07.3–281 Replacement of holder for fuel pump, fuel filter and fuel reservoir

Holder has been modified to improve installation
position and to increase rigidity.

Model 107, 123
A Former version
B Present version

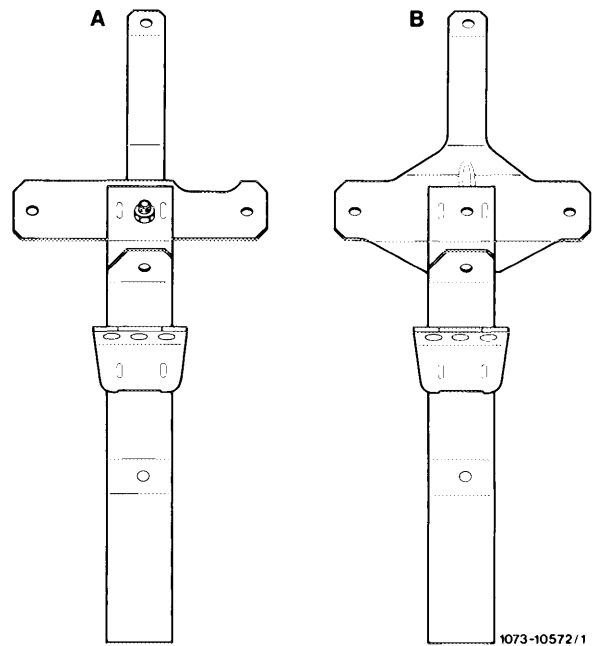
On model 126 the shape of the fuel line between pump,
filter and reservoir has also been modified.

Model 126
A Former version
B Present version

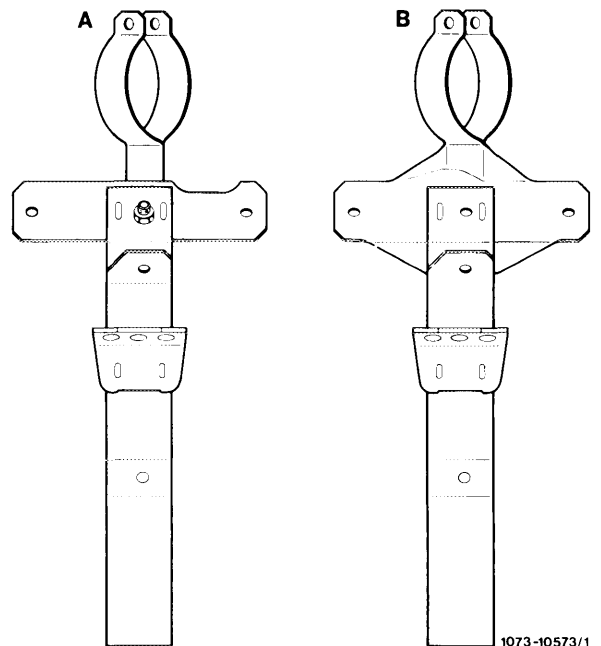
In front of fuel filter (21) is an additional pressure compensating valve (27), which closes in the event of pressure in system. If the fuel volume in system is reduced when the fuel is cooling down, the pressure compensating valve will open. This will prevent that the control piston in fuel distributor will be pulled to full load under influence of vacuum, since otherwise during a cold start the full fuel quantity might be injected for a short period and the engine might be excessively enriched.

- 86 Fuel filter with damper
- 87 Fuel pump
- 95 Diaphragm damper

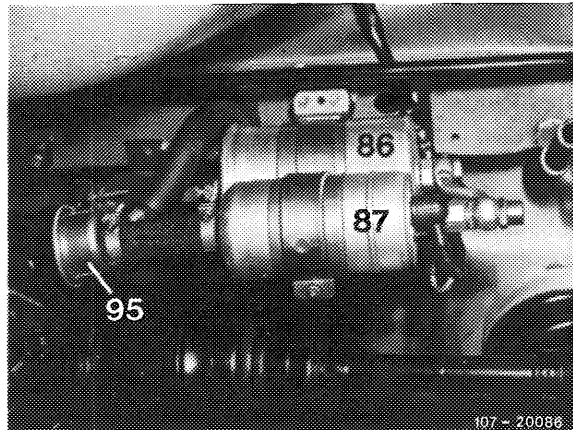
On models 107 and 126 fuel filters will be installed with damper (86), as well as a diaphragm damper (95). This will reduce noises caused by fuel pump.

On vehicles with lower chassis end no. the components can be subsequently installed in the event of complaints about "Fuel pump loud".

Present layout
 6 Holder for fuel pump and filter
 12 Leak line
 14 Pressure reservoir
 15 Holder for pressure reservoir
 19 Fuel hose
 21 Filter
 22 Fuel pump
 24 Damper
 26 Fuel pressure line
 27 Fuel compensating valve
 28 Clamp for pressure compensating valve
 29 Closing cone
 30 Coupling nut

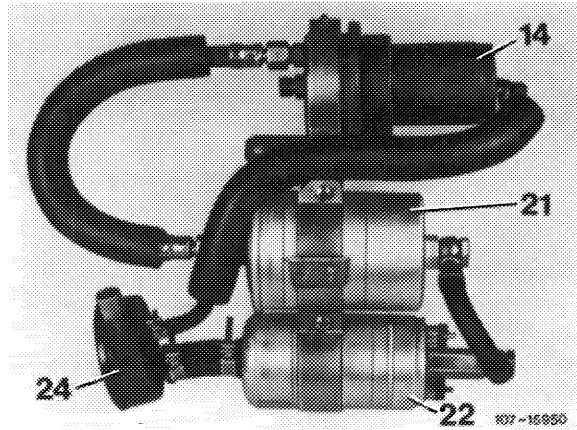
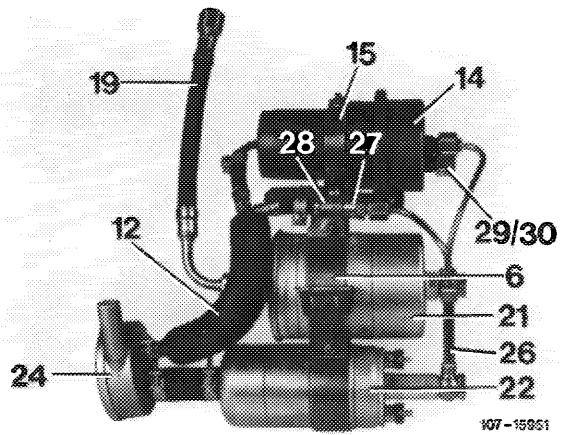
When exchanging fuel filter (21), fuel pump (22) or pressure compensating valve (27) make sure that a plastic sheet or plastic sleeve is mounted between these parts and holder (6, 15, 28). Sleeve should project on both sides of holder, since direct contact of parts with holder may lead to contact corrosion.

For conversion, the following parts may be used again:

Fuel pump,
 suction damper,
 pressure reservoir,
 fuel filter.

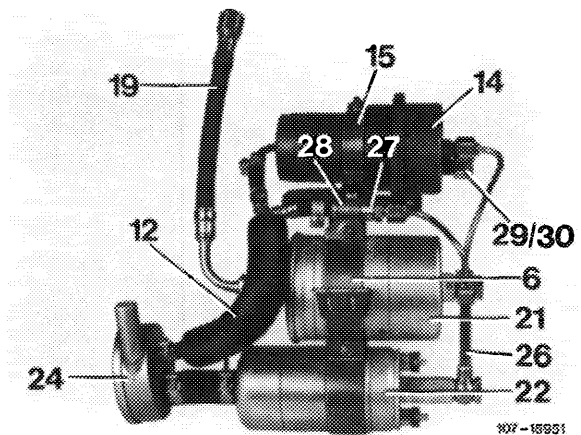
9 Assemble with components of conversion kit pump assembly, as shown in illustration. Slip fuel pump (22) up to bead into holder (6) and mount clamp (28) for pressure compensating valve (27) under holder of pressure reservoir. Prior to tightening screws of holder, position fuel pressure line (26) at pump, filter and pressure reservoir, align parts in relation to each other and tighten screws. On pressure reservoir, close the off-center connection with a closing cone (29) and a coupling nut (30).
